SERVICE BULLETIN

Classification: BT95-012	Reference: NTB95-008	Date: January 25, 1995
-----------------------------	-------------------------	---------------------------

1995 MAXIMA SPARE TIRE COVER RATTLE NOISE

APPLIED VEHICLE(S): 1995 Maxima (A32)

Figure 1

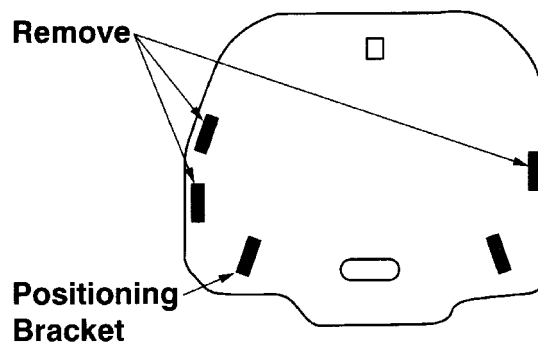
1. Remove the three (3) pieces of the foam tape originally installed on the bottom of the spare tire cover (figure 1).

Figure 2

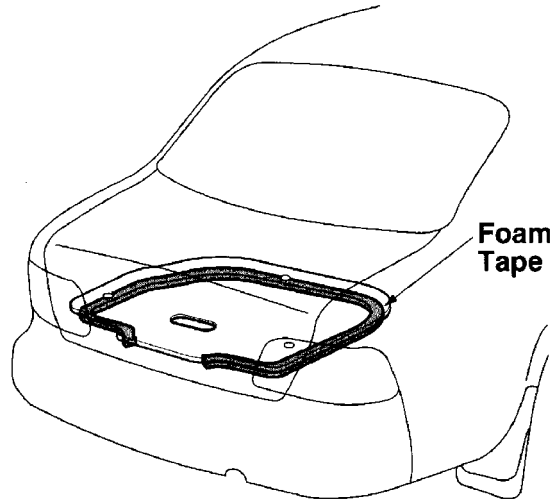
2. Install foam tape around all edges of the spare tire cover except the edge below the handle opening (figure 2).

Foam tape to be used is 3M SCOTCHFOAM Black Vinyl Foam Tape. Tape can be purchased from 3M as part number 06370, tape No. 4504 Size: 3/4 in. Contact your local 3M representative or call 1(800) 521-8180 extension 6890 for the number of the nearest distributor.
